This document is a tool to help ensure appropriate due diligence has been taken prior to site clearance/works. Evidence is required to demonstrate all tree clearance has been suitably reviewed and can be justified.

Name	Signature		Date
Application made by:	MDjv			20/06/2023
Location (Sector/Site Name):	Interim Taxi Rank			
LAA/LAP/Site Reference	LP00862_T_F120 and LP00861_T_F107			
Work Package number:	N/A			
Date of Tree Panel:			20/06/2023	
Site Description:	Interim Taxi Rank			
Reason for clearance:	<p>In order to have the lampposts lowered to instal the lamps, we need to trim some branches around two lampposts and have the clearance necessary so the posts can be lowered and reset without hitting the tree branches.</p> <p>In addition, there is a current amount of obstructive foliage obscuring the luminaires, so the leaves will not give a good light spread or provide a suitable LUX reading.</p> <p>See below sketches with the demarked areas to be trimmed.</p>

Drawing No 1: Location of the tree LP00862_T_F120 and LP00861_T_F107

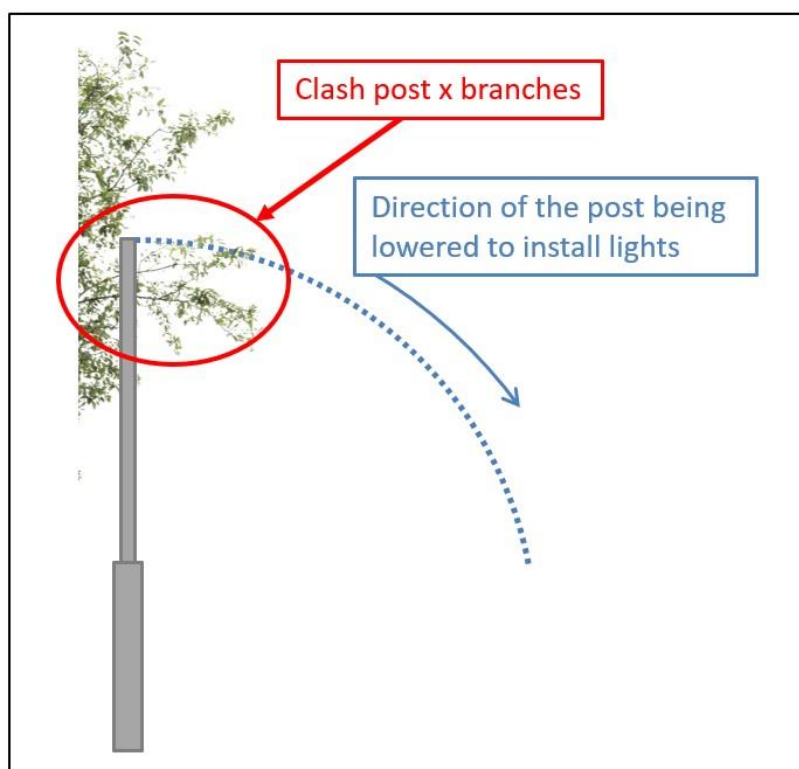
No trees identified for removal. Request to prune the branches indicated above, from trees LP00862_T_F120 and LP00861_T_F107 under Arboricultural Watching Brief supervision.

Proposal Endorsed/Not Endorsed:	Endorsed
Conditions	NA
